UNITED STATES  
NUCLEAR REGULATORY COMMISSION  
WASHINGTON, D. C. 20555

Approval and issuance  
of revised 101 certificate  
and new 102 certificate  
June 6, 1991  
models 117 and AN/AAS-38A

REGISTRY OF RADIOACTIVE SEALED SOURCE AND DEVICES  
SAFETY EVALUATION OF DEVICE  
(AMENDED)

MODEL: AN/AAS-38A LASER DESIGNATOR

Figure No. 1 Laser Transceiver (Top View)

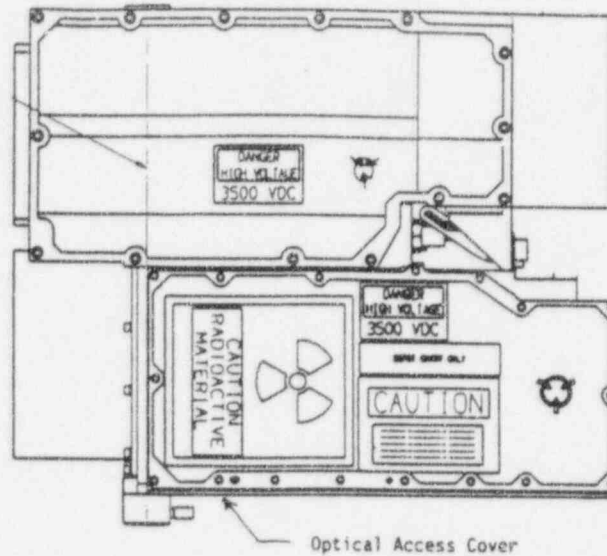
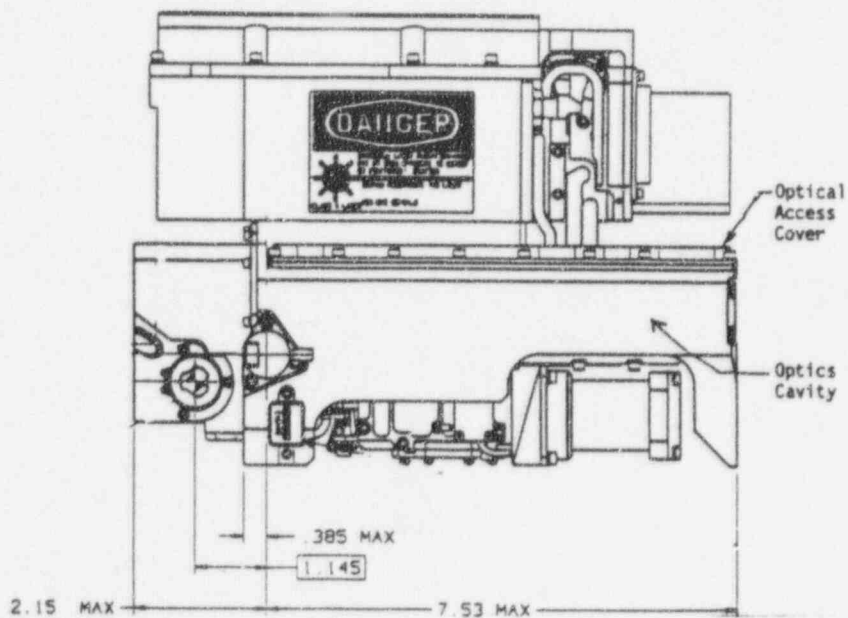
The device is contained in an environmental controlled cavity (AN/AAS-38A FLIR Pod). The device shown in Figure Nos. 1 and 2, contains two NRC-approved americium-241 (AM-241) sources Model AMM, for the removal of static charge, one at each end of the laser's Q-Switch crystal permitting it to maintain its large characteristic discrimination ratio. The two sources are screwed and secured into the Optical Access Cover which is located on the laser transreceiver directly over the optics. The cover is an aircraft standard aluminum alloy machining, 7.5 inches long by 3.4 inches wide by 0.4 inches high, which mounts the sources. The optical elements of the laser are mounted within a sealed cavity directly below the cover. The cavity is approximately 1.7 inches deep and is also machined from aluminum. The sources are shown attached to the cover in Figure No.5. The minimum thickness of the cover is .040 inches. The sources are placed approximately 1.5 inches apart and are threaded into the cover. An O-ring is placed between the chassis and cover. The cover is secured with seventeen screws and is opened only for depot maintenance. This prevents the ingress of moisture and the cavity is filled with dry nitrogen. Once assembled there is no access to the Am-241 sealed sources.
